# Network Video Recorder

## Version: V3.4.96 build171106

### Release Note

<b>Firmware</b> <b>Basic Information</b>	Firmware Version:	V3.4.96 build171106
	SDK Version:	V5.3.1.25
	ONVIF Protocol:	ONVIF V2.5.0
	Ultra CMS	v2.6.1.50 Build170123

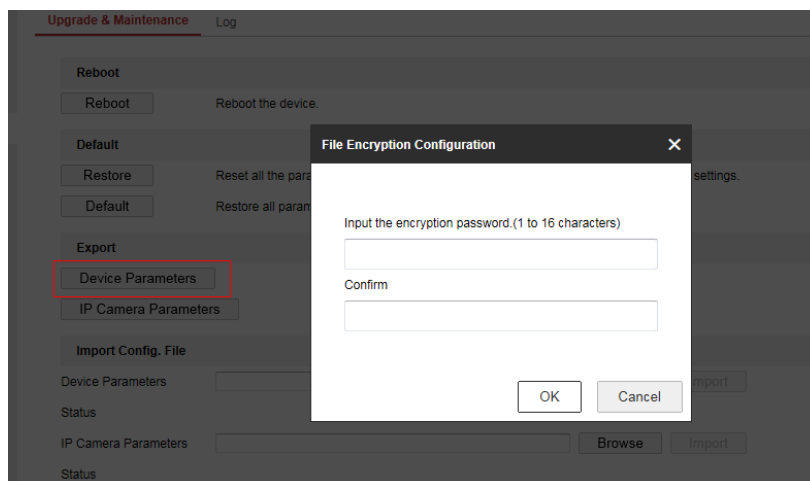
(6) User can disable/enable IP camera occupation detection, when this function is enabled, NVR will detect whether IP camera is already connected to other device/client.

## 2. [ONVIF]

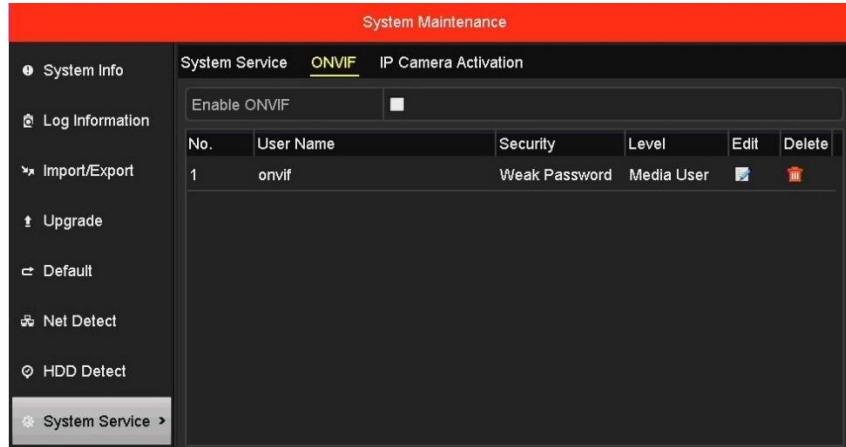
User can disable/enable ONVIF protocol, create independent account for ONVIF server service.

## 3. [IP Camera Activation]

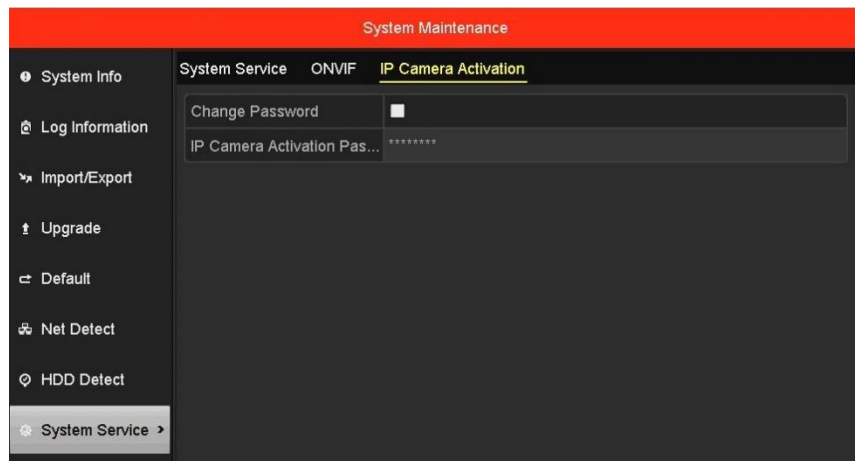
In previous version, NVR uses admin password to activate IP camera. From this new version, users can set IP camera activation password independently which is not required to be same with admin password.
